OXFORDSHIRE COUNTY COUNCIL'S RESPONSE TO CONSULTATION ON THE FOLLOWING DEVELOPMENT PROPOSAL

Application no: 23/03428/OUT

Proposal: Outline planning application for the construction of up to 140,000 sqm of employment floorspace (use class B8) with ancillary offices and facilities and servicing and infrastructure including new site accesses. Internal roads and footpaths, landscaping including earthworks to create development platforms and bunds, drainage features and other associated works including demolition of the existing farmhouse.

Location: OS Parcel 7921 South Of Huscote Farm And North West Of County Boundary, Daventry Road, Banbury

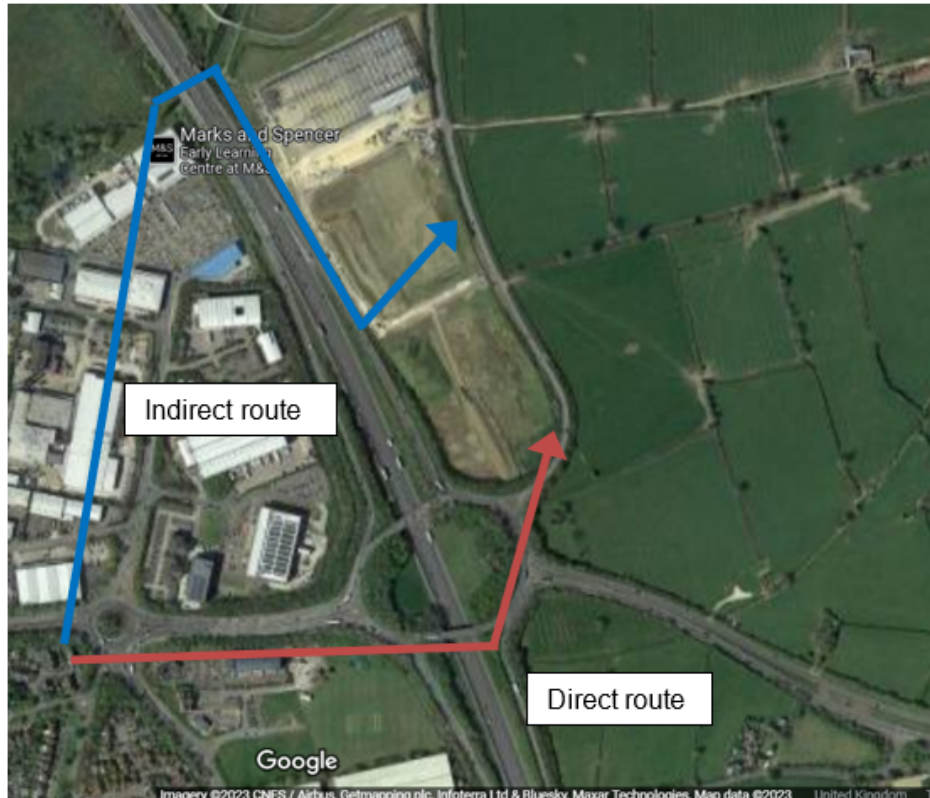
Other established residential areas across Banbury (Grimsbury, Hardwick and Neithrop) have been examined to determine the estimated distances and walking times from the area centres to the site. The findings are as follows:

Grimsbury 2410m equivalent to 29 mins.

Hardwick 4830m equivalent to 58 mins.

Neithrop 4990m equivalent to 59 mins.

Extract from Drg. No. 072305-CUR-XX-XX-DR-C-95001 Rev. P01
Site Estate Road, Paths & Cycle Path GA
Submitted with 20/02153/DISC

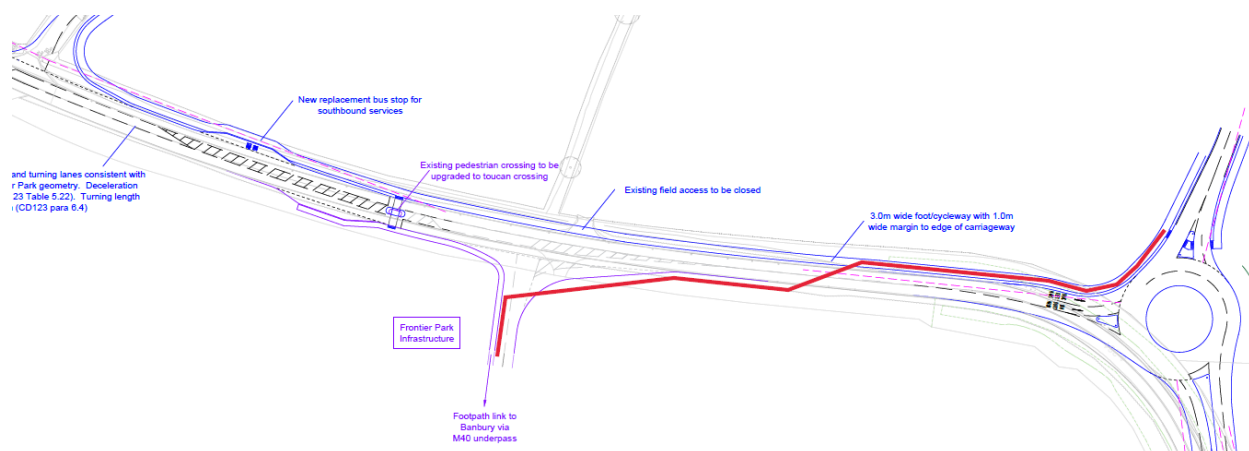
When using the safer but longer route via the M40 underpass, cyclists will be presented with a different safety hazard. The path leading south-eastwards from the underpass is initially a cycletrack, but where it joins the Frontier Park access road (shown brown in the image below) cyclists must proceed on-carriageway, eventually emerging at the A361 junction. This access road will be serving three large warehouses so will experience a high proportion of HGV movements.
